YANKEE ATOMIC ELECTRIC COMPANY

Subject: Yankee Rowe Proposed ECCS Modification for Core XIII

YANKEE ROWE ECCS MODIFICATION

PROPOSED CHANGE NO. 145

SK-2

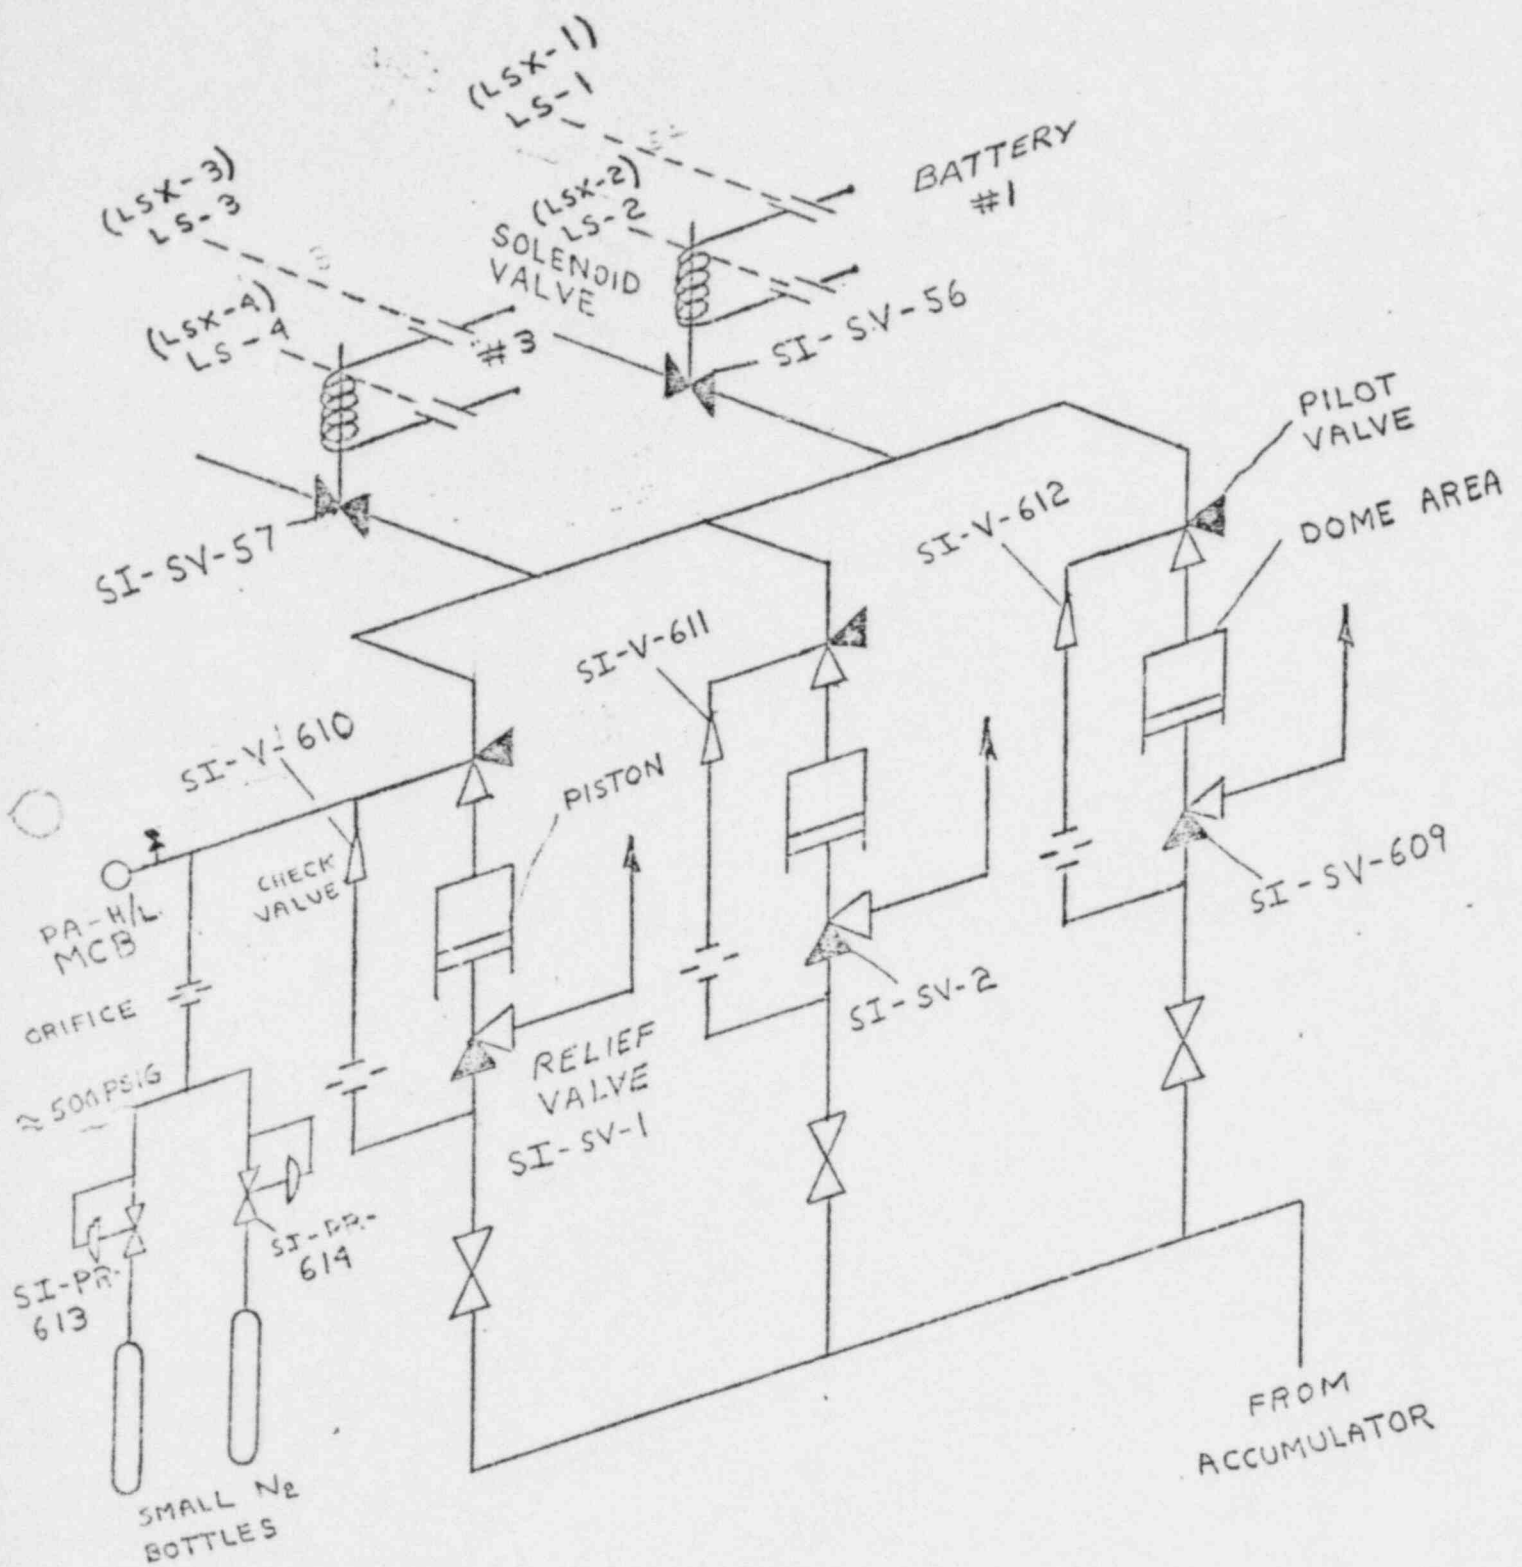
A third relief valve (SI-SV-609) is being provided for increased accumulator venting capability (SK-2). Line pressure act above and below the main piston of the safety valves. Since the area above the piston is greater than the area below the piston, the safety valves remain closed.

ELEMENTARY DIAGRAM FOR RELIEF VALVES AND 4" PNEUMATIC VALVE

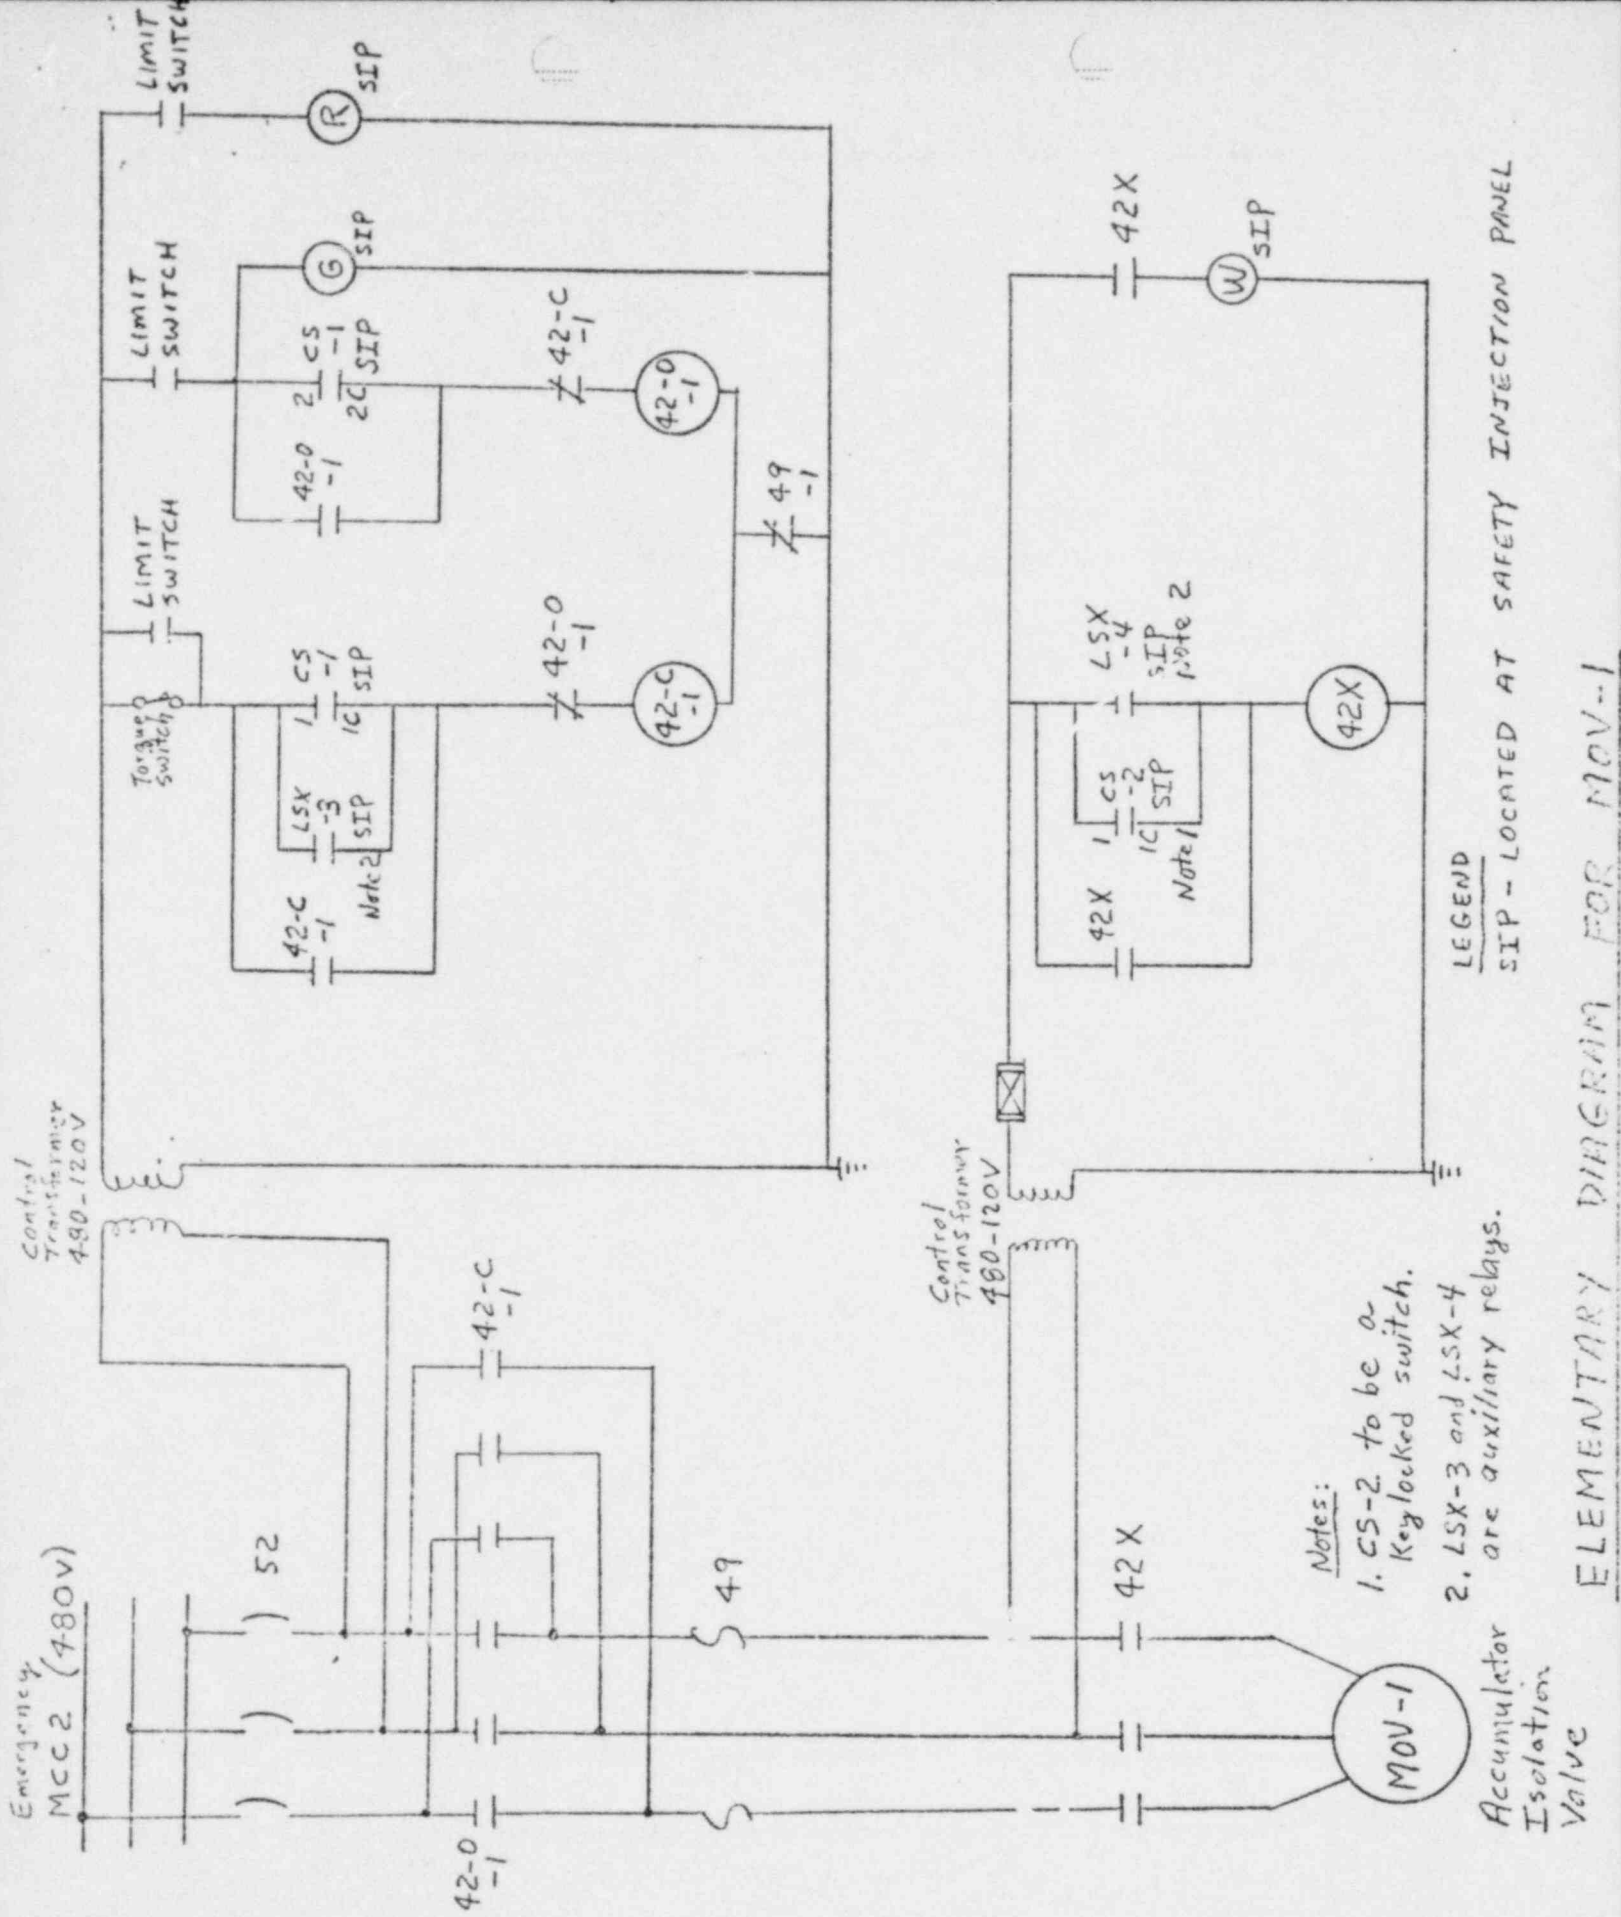
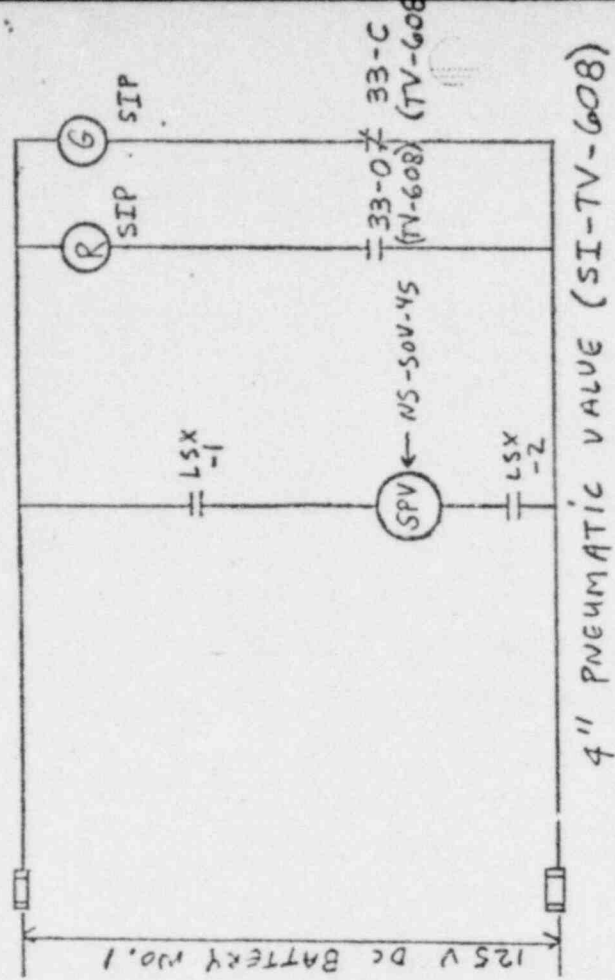
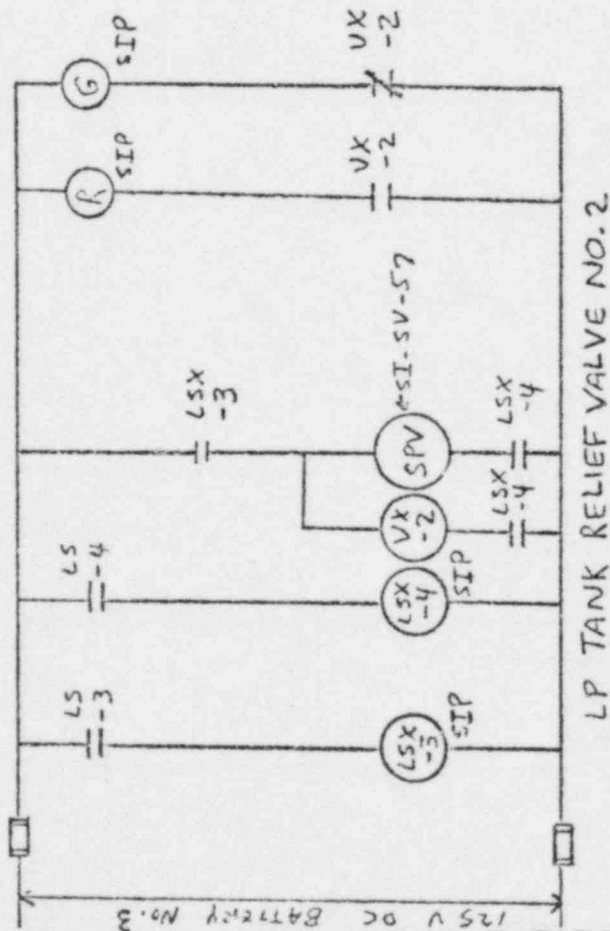
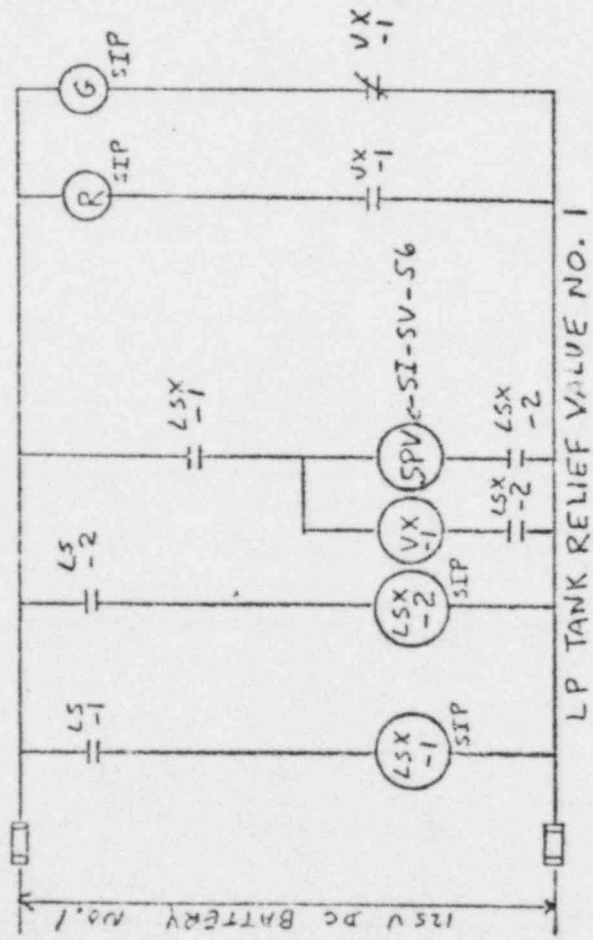
Safety Valves (See Elementary Diagram)

There are two solenoid valves (SI-SV-56 & 57) either of which can bleed the pressure off the safety valve dome causing all the valves to lift.

When accumulator level switches LS-1 and LS-2 close, they actuate their respective auxiliary relays LSX-1 and LSX-2. Contacts from these relays are used to energize solenoid valve SI-SV-56 which opens causing the safety valves to open. Both level switches and auxiliary relays must be actuated for the solenoid valve to be energized.

4" Pneumatic Valve (See Elementary Diagram)

When accumulator level switches LS-1 and LS-2 close, they actuate their respective auxiliary relays LSX-1 and LSX-2. Contact from these relays are used to energize solenoid valve NS-SOV-45. When the solenoid valve is energized, it opens and nitrogen is admitted to the operator which closes the 4" pneumatic valve (SI-TV-608).

MOV-1 (See Elementary Diagram)

During normal operation, MOV-1 is open. The closing coils in the dual motor starters are both deenergized. When the accumulator level descends to the 150 ft level, level switches LS-3 and LS-4 close and actuate their respective auxiliary relays LSX-3 and LSX-4. Contacts from these auxiliary relays are used in the closing circuit of the dual motor starter. When the contact from auxiliary relay LSX-3 closes, the closing coil of the reversing motor starter is energized. This action permits the control circuit of the non-reversing contactor to receive power. Since the contact from auxiliary relay LSX-4 has previously been closed, the closing coil of the non-reversing contactor is energized, and MOV-1 closes.
